Re: Comfort Dental Coronado, 5820 Manual Blvd, Traffic Circulation Layout
Architect's Stamp dated 07-24-13 (H18-D068)

Re: Comfort Dental Menaul Traffic Circulation Variance Request

**Re: Comfort Dental Coronado, 5820 Menaul Blvd, Traffic Circulation Layout
Architect's Stamp dated 6-05-13 (H18-D068)**

**Re: Comfort Dental Coronado, 5820 Menual Blvd, Traffic Circulation Layout
Architect's Stamp dated 4-10-13 (H18-D068)**

01 Existing Site Plan
 Scale: 1" = 20 ft

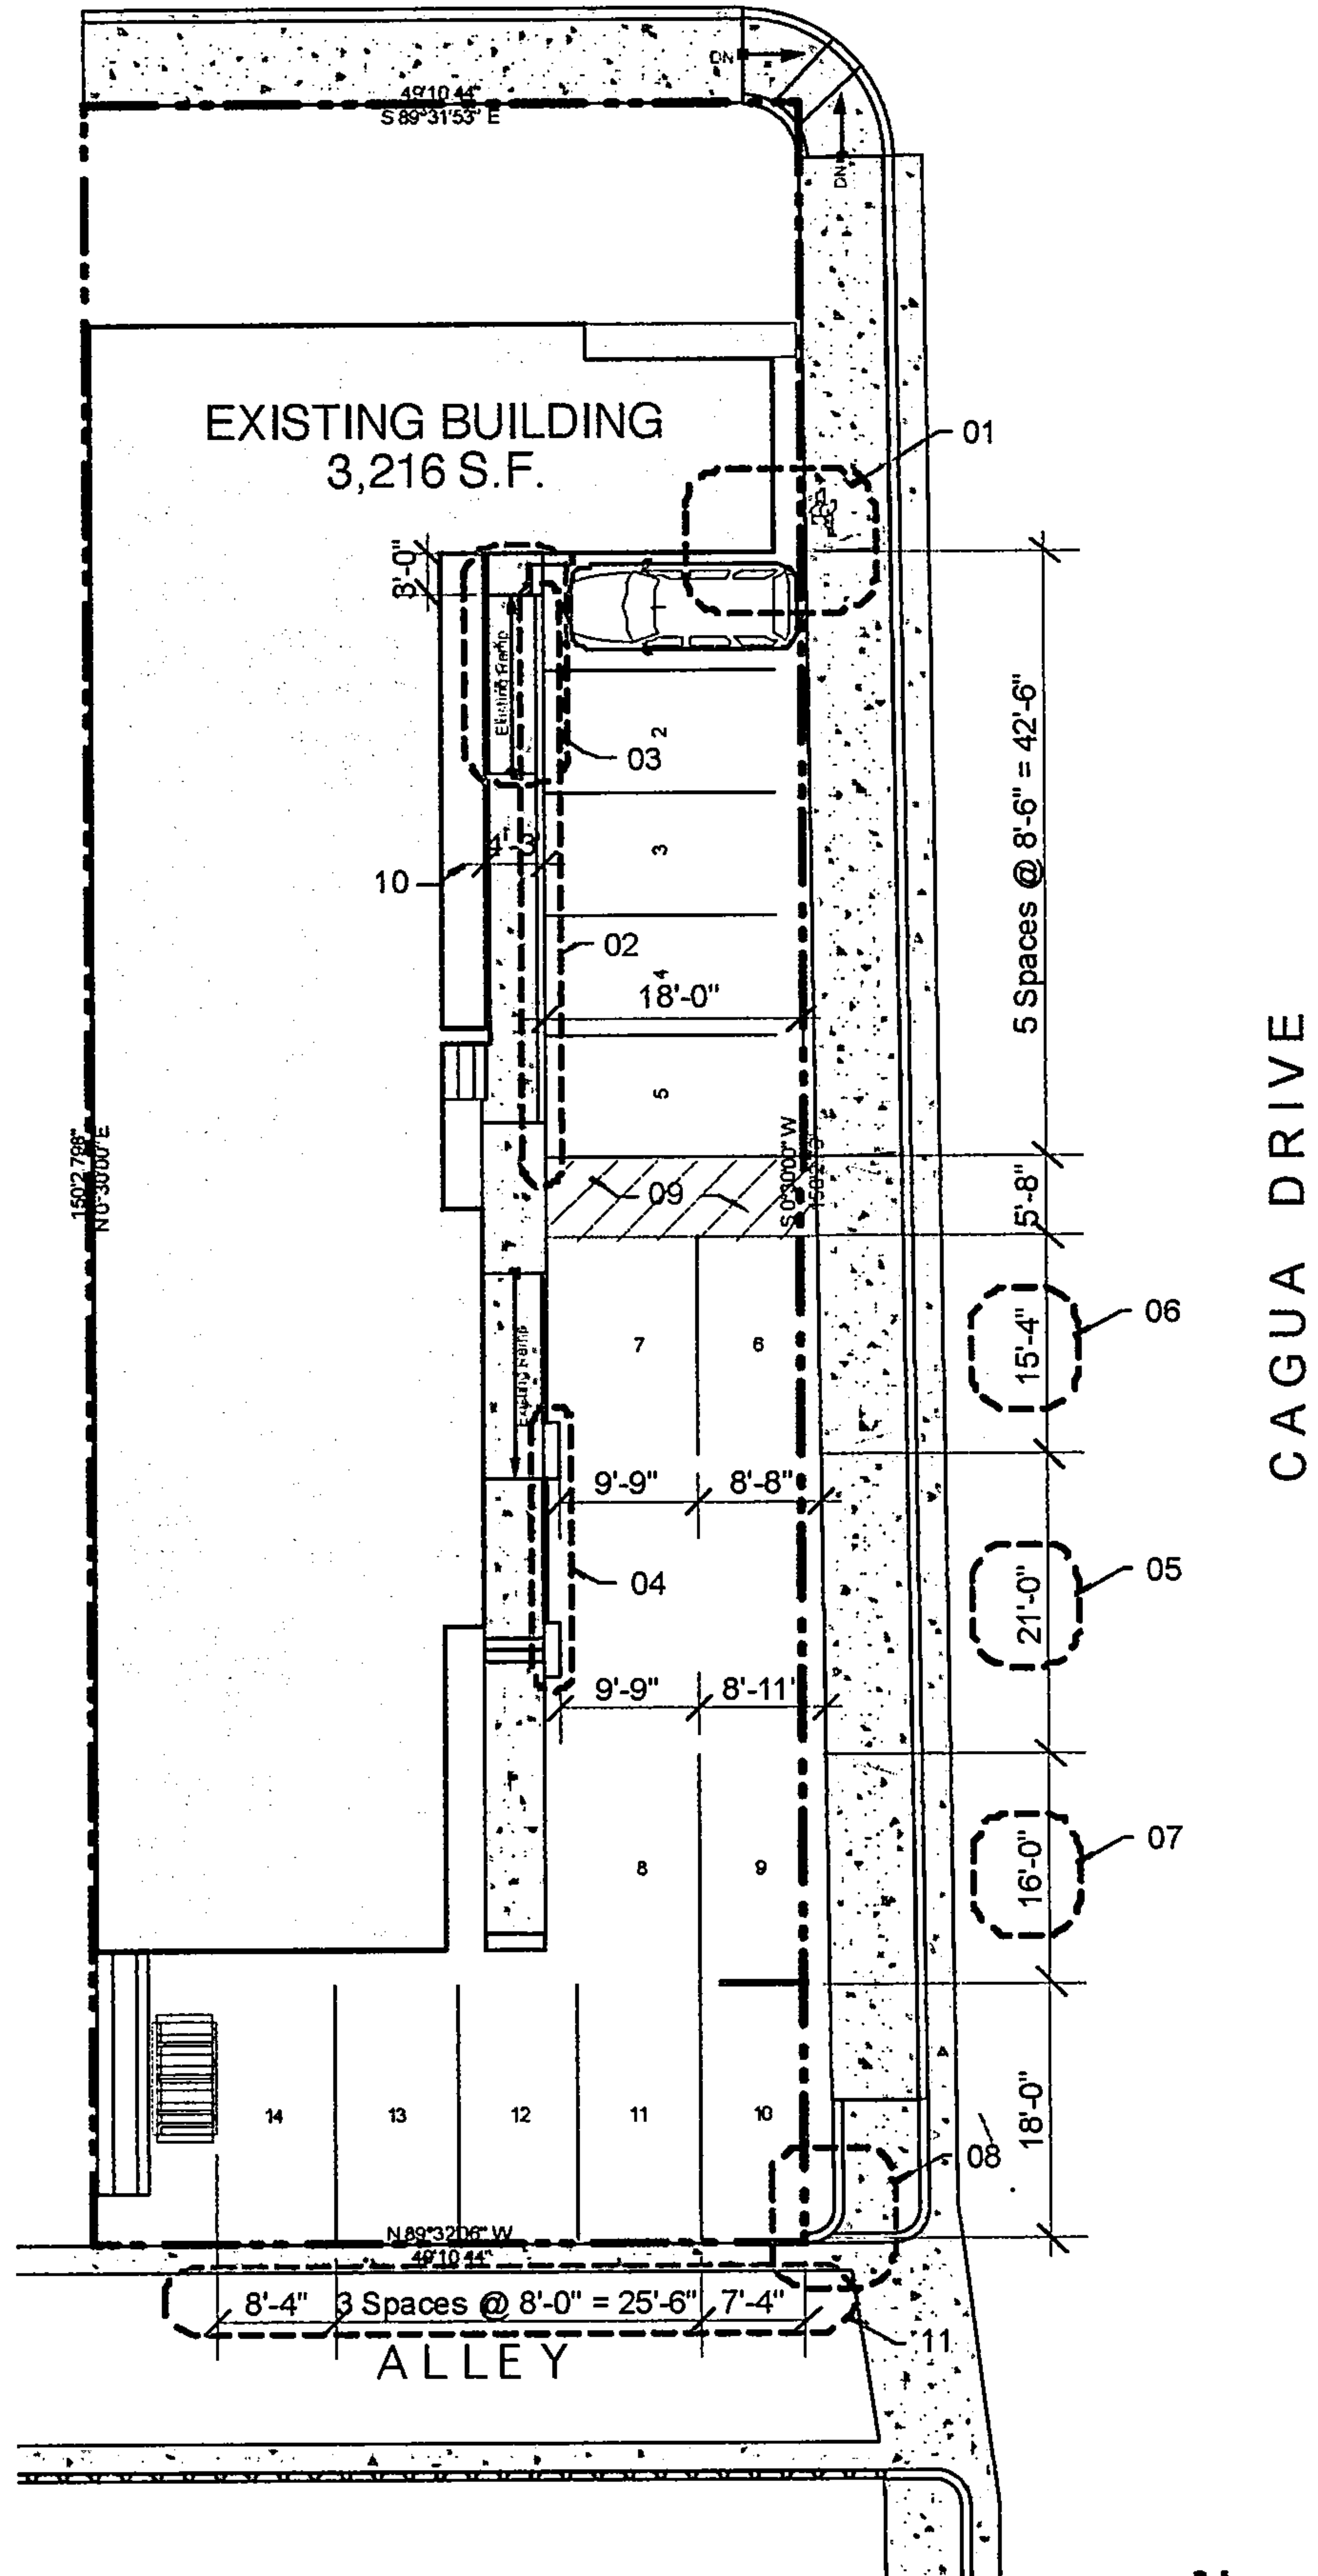
Item 01 - A blind corner exists where a pedestrian and vehicle backing onto Cagua Drive cannot see each other generating a potential catastrophic condition.

Item 02 - An existing curb and step condition generates a tripping hazard directly in front of 5 existing parking spaces immediately adjacent to the front entry of the building.

Item 03 - An existing accessible ramp leading into the main entry of the building does not meet accessibility (ANSI) guidelines as it is too steep and does not provide the proper width and handrail requirements.

Item 04 - There is no 5' keyway appropriate for vehicles to back into from spaces denoted as #6 - #9.

Item 05 - The 21'-0" drive isle width does not meet regulatory requirements of 24'-0" min. as required for 90 degree parking.

Item 06 - The existing 15'-4" length of spaces denoted as #6 & #7 does not meet regulatory requirements as to the minimum length of 18'-0" allowable for a parking space.

Item 07 - The existing 16'-0" length of spaces denoted as #8 & #9 does not meet regulatory requirements as to the minimum length of 18'-0" allowable for a parking space.

Item 08 - The existing parking space denoted as #10 requires a vehicle to drive over an existing 6" curb in order to access the space.

Item 09 - There is currently no designated accessible parking space. An identified accessible space denoted at note #9 on the exhibit is believed to be the intended accessible location, which is not located close to the front door due to the concrete curb and thus generates a longer travel distance from the accessible space to the main building entrance.

Item 10 - The pedestrian sidewalk leading to the front door is currently 4'3" wide.

Item 11 - The southern parking spaces do not meet required minimum widths per zoning ordinance.

** The proposed configuration eliminates the blind corner condition eliminating the situation by pushing the closest parking space down away from Menaul Blvd.*

** The proposed configuration generates a traditional 6" curb stepping onto a sidewalk for better pedestrian safety.*

** The proposed configuration provides an ANSI acceptable ramp leading into the front entrance of the building. The new ramp will meet appropriate slope and handrail requirements.*

** The proposed configuration eliminates the inappropriate 90 degree parking stalls, thus eliminating the inappropriate drive isle width and lack of appropriate keyway.*

** The proposed configuration provides a landscape buffer buffering vehicles from the overhang curb condition.*

** The proposed configuration provides an appropriate accessible parking space with an 8'-0" wide van isle in close proximity to the front door of the building.*

** The proposed configuration provides a 5'-8" wide sidewalk along the front of the parking stalls maximizing the pedestrian sidewalk for patrons of the facility*

** The proposed configuration provides the minimum 8'-6" parking space width.*
